#### **Addendum 43 – UN Regulation No. 44**

#### **Revision 3 - Amendment 6**

Supplement 13 to the 04 series of amendments – Date of entry into force: 19 July 2018

#### **Uniform provisions concerning the approval of restraining devices for child occupants of power-driven vehicles ("Child Restraint Systems")**

Figures of Strapped child

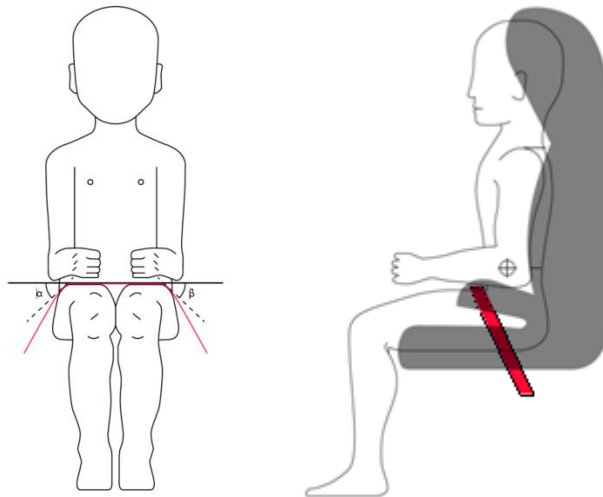
Paragraph 6.2.2., amend to read:

"6.2.2. All restraint devices utilizing a "lap strap" shall positively guide the "lap strap" on both sides to ensure that the loads transmitted by the "lap strap" are transmitted through the pelvis. The assembly shall not subject weak parts of the child's body (abdomen, crotch, etc.) to excessive stresses.

In the case of booster cushions and booster seats , the lap portion of the adult seat belt shall be positively guided on both sides to ensure that the loads are transmitted by the adult lap belt are transmitted through the pelvis. The positive guidance of loads over the pelvis shall be realised from the moment that the child is installed; the lap belt shall pass over the top of the thigh, just touching the fold with the pelvis. The angles  $\alpha$  and  $\beta$  between the tangent line in which the belt touches the thighs and the horizontal shall be greater than  $10^\circ$ .
